**APPLICATION BY RES UK & IRELAND LIMITED, DATED 27 MARCH  
2009, FOR CONSENT UNDER SECTION 36 OF THE ELECTRICITY ACT  
1989  
TO CONSTRUCT AND OPERATE A  
100MW WIND TURBINE GENERATING STATION IN POWYS, MID WALES  
("LLANBRYNMAIR")**

DECC REFERENCE: LLANBRYNMAIR BERR/2009/004

**Rebuttal  
on Dormice  
of  
Elisabeth Halliwell BSc (Hons), PhD**

**Natural Resources Wales**

**Figure 1** Map showing the distance between the dormouse record at SN917023 and the Llanbrynmair access route at Talerddig

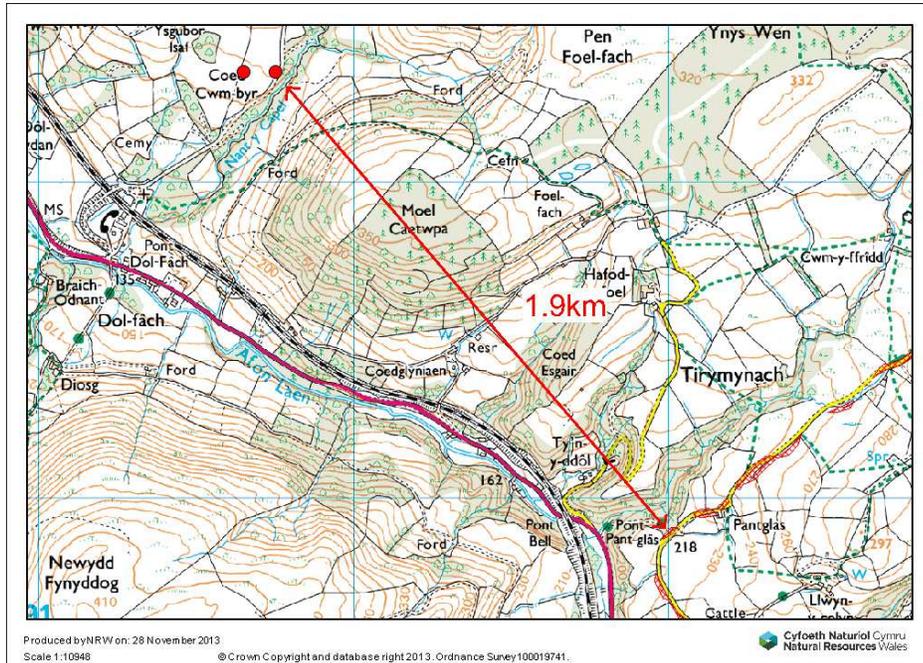
The one record that was found in the desk study, referred to in the quote above, is described as being over 4.5km from the nearest proposed access works.

However, the map below shows that this record is actually only 2km from works on the access route.
